# Access Compliance Report

## Public Rights-of-Way

Intersection ID: 30340	Main Street: DULIN_CREEK_BV	Cross Street: FOX_SWAMP_RD	Location: NE
ADA ID: D53C3682AF14	Ramp Type: PerpDiag	Initial Pass/Fail: Fail	Overall Compliance: No
Severity Score: 8.75			
Codes/Mitigation Info/Possible Solution		Field Measurements/Component Compliance

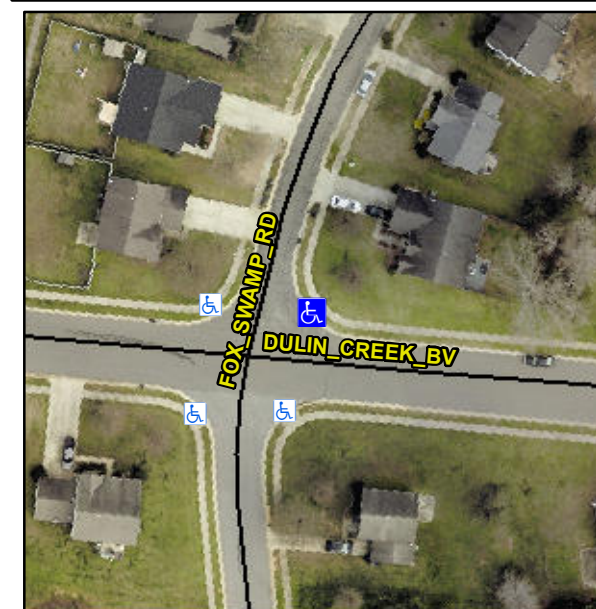
Compliance	Description	Data	Compliance	Description	Data
N/A	Ramp Length (in)	51.0	Yes	Ramp Slope (%)	7.2
No	Ramp Width (in)	45.0	Yes	Ramp XSlope (%)	1.9
N/A	Flare Type LT	N/A	N/A	Flare Type RT	N/A
N/A	Flare Slope LT (%)	N/A	N/A	Flare Slope RT (%)	N/A
N/A	Flare Traversable LT?	N/A	N/A	Flare Traversable RT?	N/A
N/A	Landing Length (in)	N/A	N/A	DWS Provided?	N/A
N/A	Landing Width (in)	N/A	N/A	DWS Contrast?	N/A
N/A	Landing Slope (%)	N/A	N/A	DWS Length (in)	N/A
N/A	Landing X Slope (%)	N/A	N/A	DWS Full Width?	N/A
N/A	Landing Curb? (Y/N)	N/A	N/A	DWS Offset (in)	N/A
N/A	Shared Landing?	N/A			
N/A	Gutter Ponding?	N/A	N/A	Gutter Slope (%)	N/A
N/A	Gutter Lip Ht (in)	N/A	N/A	Gutter X Slope (%)	N/A
N/A	Painted X Walk1?	No	N/A	Painted X Walk2?	No
	X Walk 1 Direction	To W		X Walk 2 Direction	To S
N/A	X Walk 1 Width (in)	N/A	N/A	X Walk 2 Width (in)	N/A
	X Walk 1 Slope (%)	1.7		X Walk 2 Slope (%)	0.8
	X Walk 1 X Slope (%)	2.1		X Walk 2 X Slope (%)	0.4

**Remove & Replace Curb Ramp With Two New Directional Ramps or Equivalent.**

**R304.5.1**
